# SERVICE BULLETIN

Service Bulletin No.: DA C1-52-01 Rev. 0 Date Issued: January 7, 1999

Title: Canopy, Seal Replacement Page: 1 of 4

2. Effectivity: DA20-C1 aircraft S/N C0001 to C0055

Fi L/H strike and strike block

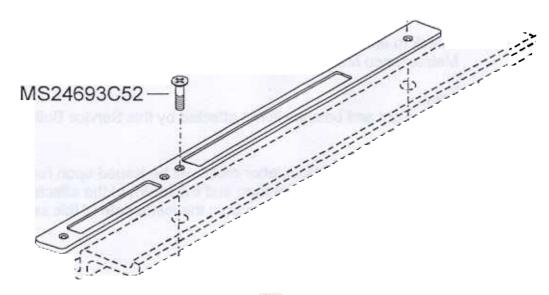
Replace canopy strike ball bearing: (see figure 1)

- Remove canopy strikes by removing two MS24693C52 screws on each strike. Retain any composite shims between strike assembly and fuselage.
- Remove retaining ring and pin from each strike.
- Remove and discard ball bearing, but retain nylon washers.
- Install washers, solid bearing (22-5600-63-00), pin, and retaining ring on each strike.
- Reinstall canopy strike using MS24693C52 screws. Ensure that any shims are reinstalled in correct orientation.

10.8 If required, adjust latching forces using the shims. Remove strike assembly (as in 10.5 above). To reduce force, remove material from shims by sanding. To increase force, add a shim, or replace shim with thicker one. It may be necessary to taper shims slightly to ensure that the strike is parallel to the latch hook when the canopy is closed. When force is within acceptable limits, install MS24693C52 screws with Loctite 222.
